Technical Bulletin	Model 944 S	Group 9
Subject: Providing Fuse Protection for Steering Pump Switch (Service Action 191)	Part Identifier 9715	Number 9108

WORK PROCEDURE
Service Action 191

ADMINISTRATIVE PROCEDURE
Service Action 191
 Providing fuse protection for Steering Pump Switch

Figure 1

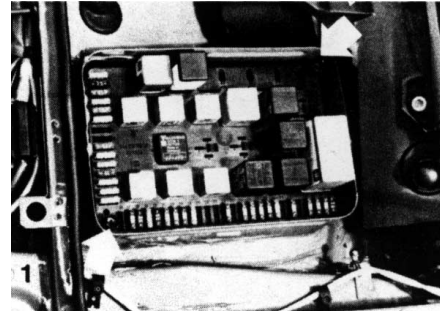
4. Remove phillips screws (arrow /Figure 1) and lift CEB from body.
5. Unlock the locking rail on CEB underside (arrow / Figure 2).
6. Pull off CEB plugs "L" and "F", if necessary, cut tie strap.

Figure 3

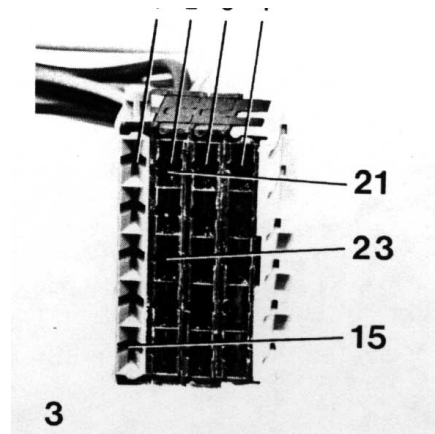
7. Remove the first element from CEB plug "L". Install the supplied wiring bridge with connector (800mm long, 0.5mm², black /yellow) into element 1, position 5 (Figure 3). Reassemble element and install plug "L" into CEB.

Figure 4

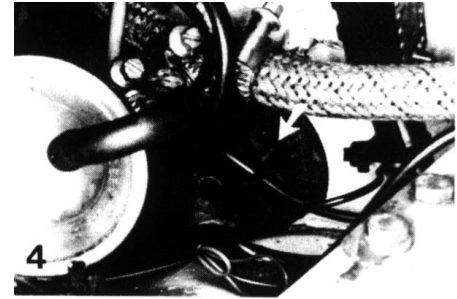
11. Remove cover from female part of wiring plug. Install solder terminal of wiring (800mm long, 2.5mm², black / yellow) in position 11 of the wiring plug. Reinstall cover of wiring plug. Route wiring through additional hole of rubber grommet in partition wall into vehicle inside CEB area (Figure 4). Open up hole in grommet by pulling off rubber nipple. Pull wiring from body well. Install and solder connector (from kit). Part Number 999 652 475 22.

Figure 5

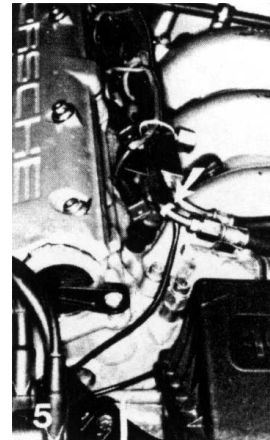
19. Route new wire from 14 pin plug through tie straps on partition wall to fuel rail. Route wiring through tie straps on fuel rail towards the belt cover. Tie down wiring on fuel rail with additional tie strap. Part Number N 020 902 4 (Figure 5).

Figure 6

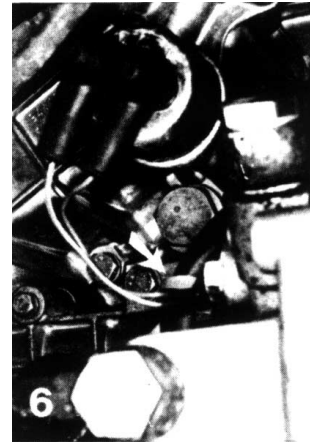
20. Route wiring between belt cover and cylinder head parallel to the oil pressure switch wiring harness. Reinstall fuel rail cover (Figure 6).
21. Lift vehicle. Remove the engine cover plate screws and remove cover plate. Use tie strap to tie wiring to harness. Pull off rubber boot and angled connections from steering pump pressure switch. Cut terminal from 0.75mm², red/blue wire. Pull insulation hose through rubber boot and cut off approximately 50mm. Loop red/blue wire and guide into insulation hose. Push newly installed wire through rubber boot (Figure 7).
